APPLICATION FOR IMPROVEMENT PERMIT FOR RESIDENTIAL SITE INDIVIDUAL WATER AND WASTEWATER SYSTEMS PROGRAM

SOIL/SITE EVALUATION for ON-SITE WASTEWATER SYSTEM

SHEET TITLE: SITE PLANS & DRAINFIELD LAYOUTS

PROJECT NAME: WILLIAM BREWSTER COMPANY, INC. – CASHION ROAD LOT 3-4 – IREDELL COUNTY, NORTH CAROLINA MAY XXXX

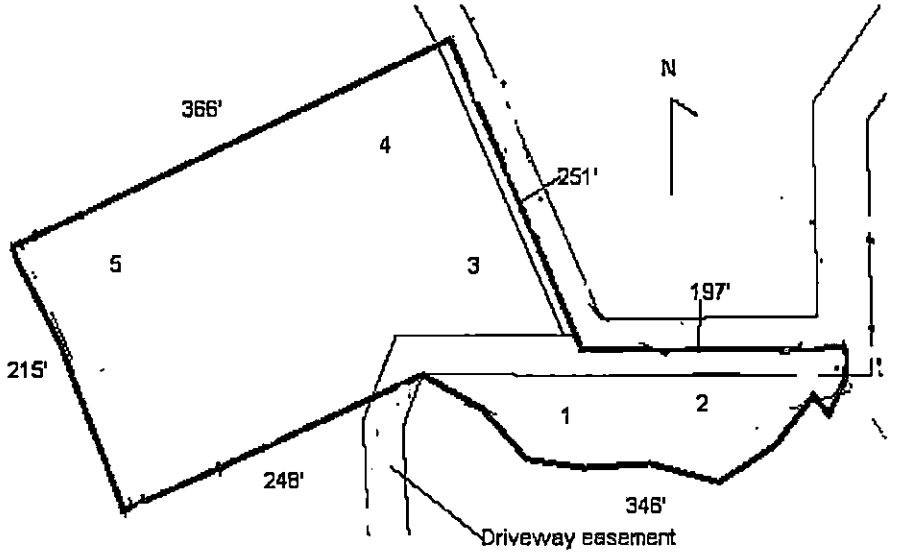
Other Factors (.1946): _____
Site Classification (.1948): UNSUITABLE
Evaluated By: W. R. Marlin, LSS, 9/18/2003, W. R. Marlin
Others Present: A. Rollans

COMMENTS: 100% repair, would need pump

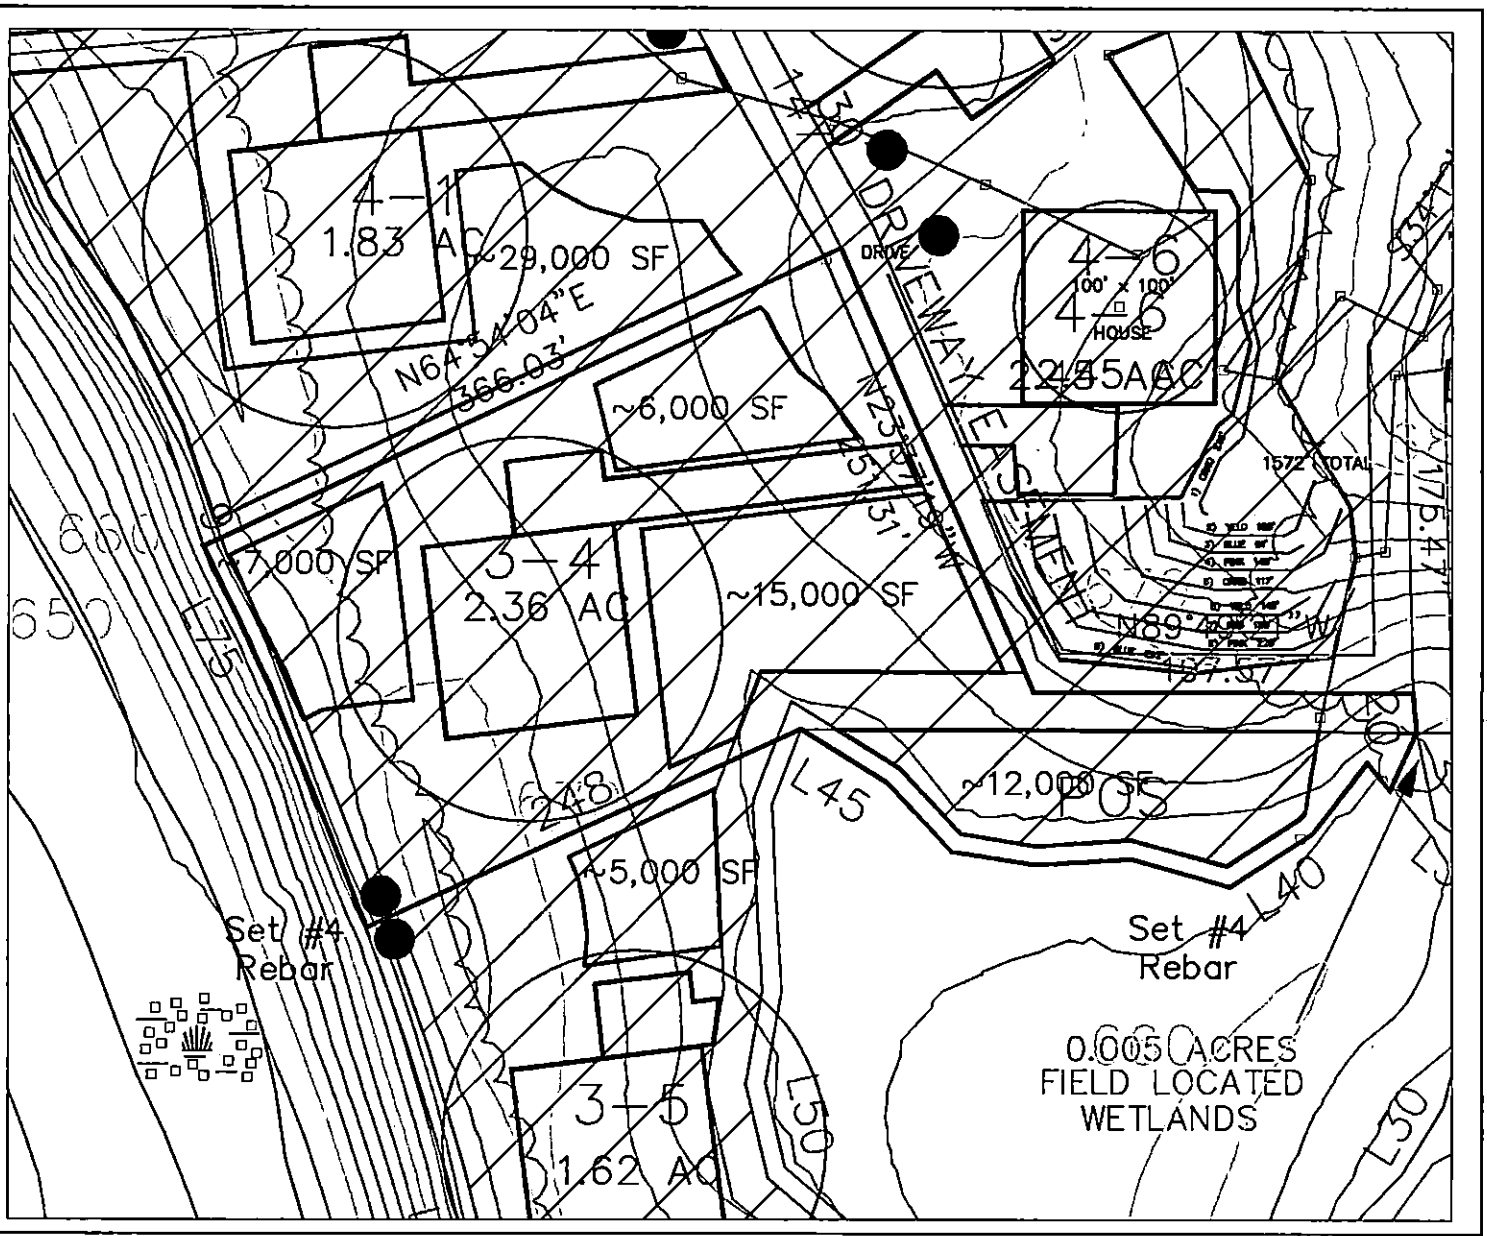
→ 6 Bedroom House

→ 0.25 CTAR

→ Driveway to be moved over to property line

→ Install 6 lines x 120' x 3'

→ 720 TLF

→ Type IIIb Pump to innovative system

→ Panel Block Repair System
